WORK PLAN FOR ADDITIONAL INVESTIGATION

German Autocraft
301 E. 14th Street
San Leandro, California

Global ID No. T0600100639
AC LOP Case # 2783

Subject: Work Plan for Additional Investigation
German Autocraft, AC LOP Case # 2783
Global ID No. T0600100639

WORK PLAN EXHIBIT

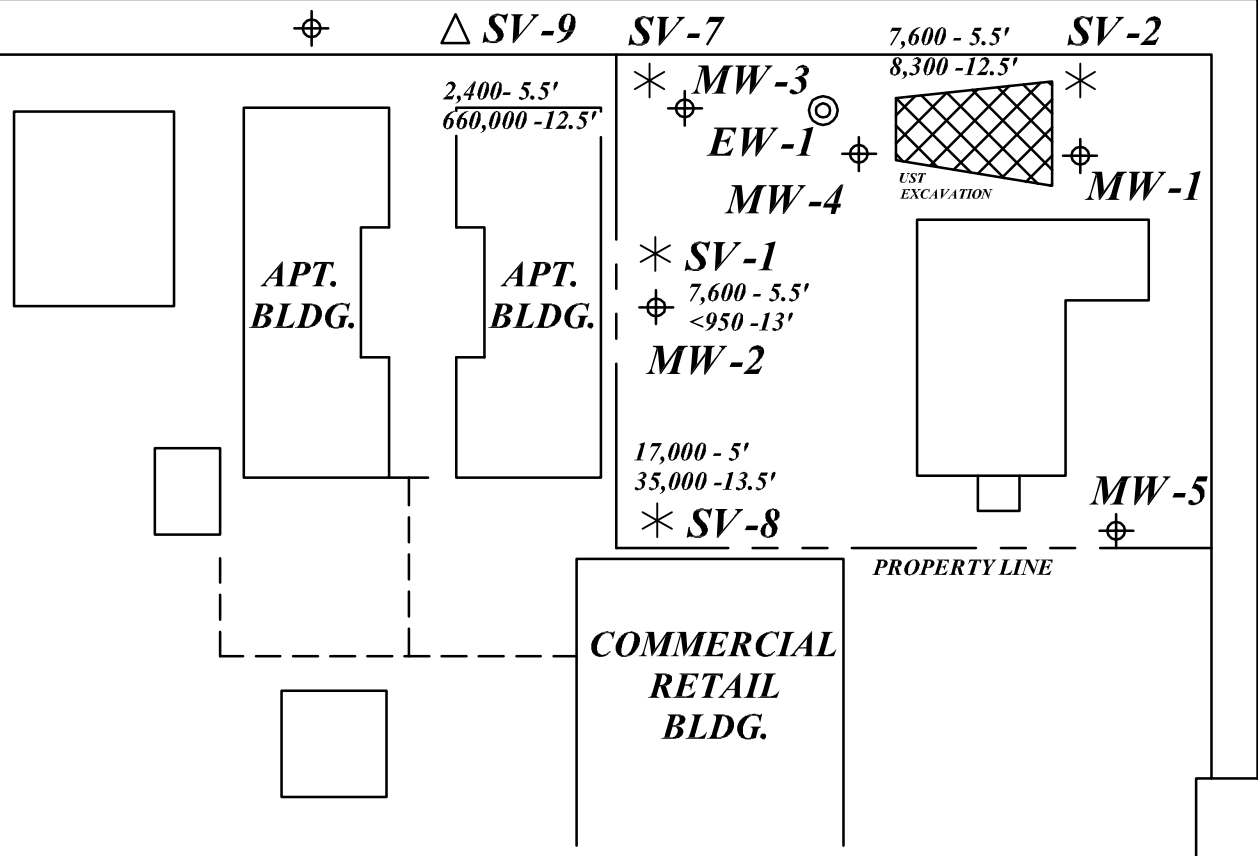
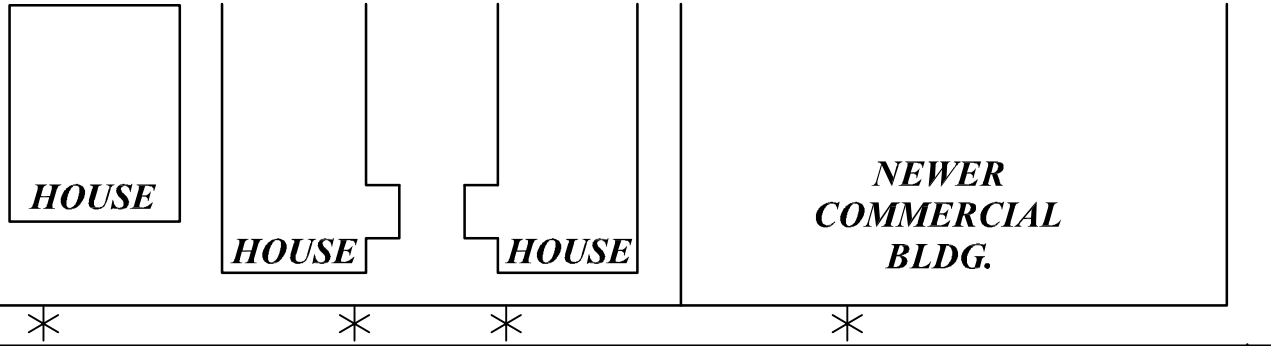
In last year's investigation, the highest concentrations of gasoline range petroleum hydrocarbon (TPHg) vapors were found at SV-7 and SV-8 at a depth of 12.5 and 13.5 feet, respectively (see Figure A). However, the shallower samples at those locations (~5

Unfortunately, the adjoining apartment complex layout is not amenable to access for a step-out point from SV-8. But, if DEH so desires, a point could be advanced in the front of the property, in the area where the SV-9 triangle has been drawn on Figure A. If SV-9 is advanced, GCI would propose to collect soil vapors from two depths using the same protocols and testing as the 2009 work.

However, per their October 2009 letter, the ACEH wants us to give the more conventional vertical extraction well approach another try, but with a larger diameter extraction well. Accordingly, GCI proposes to install a 4-inch diameter PVC well at the EW-1 location shown on Figure A. The well is planned to be screened from 10-30 feet below grade, which will encompass both the zone of the discontinuous granular material encountered about 11-14 feet below grade and the main target zone that starts about 25 feet below grade. During drilling of EW-1 soil conditions will be logged and 3-4 soil samples will be retained for moisture content and grain-size distribution testing. Zones that visually appear to have the highest granular soil content will be targeted for this sampling.

The EW-1 location is about 10 feet from MW-4 and about 20 feet from MW-3, so both those existing wells will be employed to provide vacuum measurements to be used in assessing radius of effective influence. EW-1 is purposefully not sited within the backfilled former underground storage tank location, as SVE/DPE from that area will not be reflective of what native soils will yield. In any full-scale implementation that area will obviously be targeted, but obtaining adequate vapor flow there is not expected to be problematic.
